**TSB#C1705 REMOVAL OF THE GAS SENSOR
(ALL RT/RTC/UFT/EFTC/RGHW MODELS)**

NOTICE: THE FOLLOWING EXPLAINS/CLARIFIES THE REMOVAL OF THE GAS SENSOR. EFFECTIVE 5/1/17 ALL GAS SENSORS WERE REMOVED FROM PRODUCTION OF THE ABOVE-MENTIONED MODELS TO INCREASE PRODUCT RELIABILITY

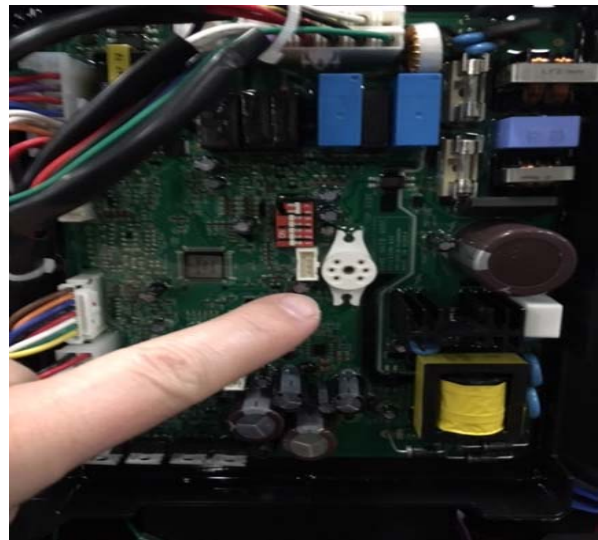
BEFORE

AFTER

THIS ELIMINATES THE ER40 CODE

IF YOU HAVE A MODEL ALREADY INSTALLED IN THE FIELD AND ARE EXPERIENCING RANDOM ER40 ISSUES, PLEASE CHECK WITH PROPER TOOLS FOR ANY GAS LEAKAGE AND IF NONE ARE PRESENT REMOVE THE SENSOR BY TURNING POWER OFF, PULL SENSOR OUT, AND THEN TURN POWER BACK ON
